PCN-20190826 TE0703-06 Under Voltage Protection Change

Company	Trenz Electronic GmbH
PCN Number	PCN-20190826
Title	TE0703-06 Under Voltage Protection Change
Subject	Trenz Electronic TE0703 Hardware Change
Issue Date	2019-09-05

This change affects TE0703 carrier of revision TE0703-06 with serial number greater than 571113

#1 Replaced R31 by 953kOhm and R35 by 147kOhm

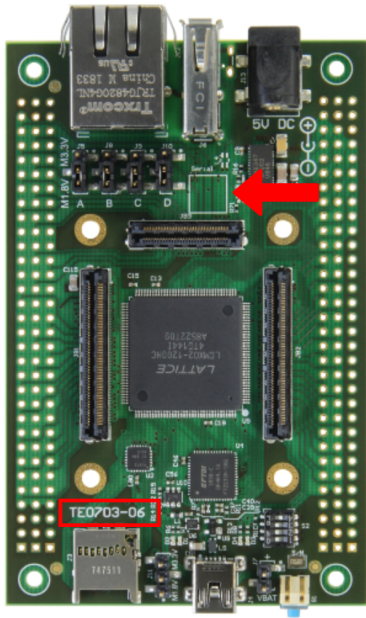
Reason: Large start up currents led due to adverse conditions (e.g. weak powersupply, long wires, increased contact resistance) to a voltage drop below the under voltage lock out limit of the input protection circuit.

Type: BOM change

Impact: Under voltage protection limit is decreased to 4.06V, which gives a larger margin for a voltage drop during start up.
